# Access Compliance Report

## Public Rights-of-Way

### (Curb Ramps)

Intersection ID: 11783	Main Street: N_GRAHAM_ST	Cross Street: W_5TH_ST	Location: S
ADA ID: 2A673130FF49	Ramp Type: Perp	Initial Pass/Fail: Fail	Overall Compliance: No
			Severity Score: 13.75

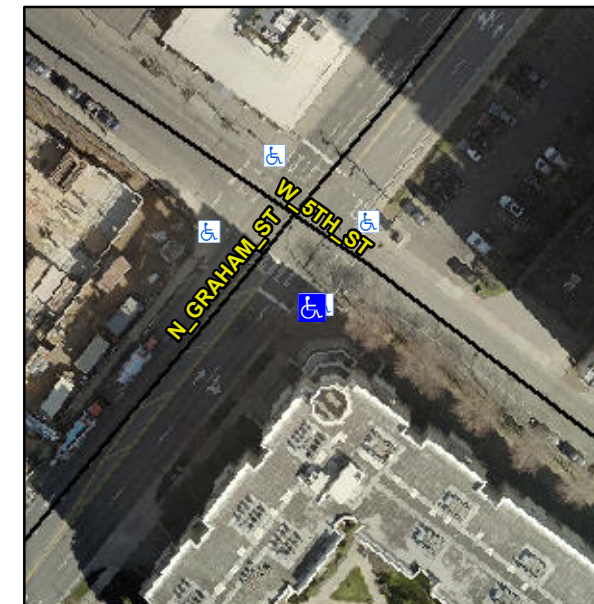
**R304.2.2, R304.5.3**

Compliance	Description	Data	Compliance	Description	Data
N/A	Ramp Length (in)	88.0	No	Ramp Slope (%)	8.8
Yes	Ramp Width (in)	53.0	No	Ramp XSlope (%)	2.6
N/A	Flare Type LT	N/A	N/A	Flare Type RT	N/A
N/A	Flare Slope LT (%)	N/A	N/A	Flare Slope RT (%)	N/A
N/A	Flare Traversable LT?	N/A	N/A	Flare Traversable RT?	N/A
N/A	Landing Length (in)	N/A	N/A	DWS Provided?	N/A
N/A	Landing Width (in)	N/A	N/A	DWS Contrast?	N/A
N/A	Landing Slope (%)	N/A	N/A	DWS Length (in)	N/A
N/A	Landing X Slope (%)	N/A	N/A	DWS Full Width?	N/A
N/A	Landing Curb? (Y/N)	N/A	N/A	DWS Offset (in)	N/A
N/A	Shared Landing?	N/A			
N/A	Gutter Ponding?	N/A	N/A	Gutter Slope (%)	N/A
N/A	Gutter Lip Ht (in)	N/A	N/A	Gutter X Slope (%)	N/A
N/A	Painted X Walk1?	Yes	N/A	Painted X Walk2?	N/A
	X Walk 1 Direction	To NW		X Walk 2 Direction	N/A
N/A	X Walk 1 Width (in)	100.0	N/A	X Walk 2 Width (in)	N/A
	X Walk 1 Slope (%)	1.7		X Walk 2 Slope (%)	N/A
	X Walk 1 X Slope (%)	1.7		X Walk 2 X Slope (%)	N/A

**Remove & Replace Entire Ramp.**
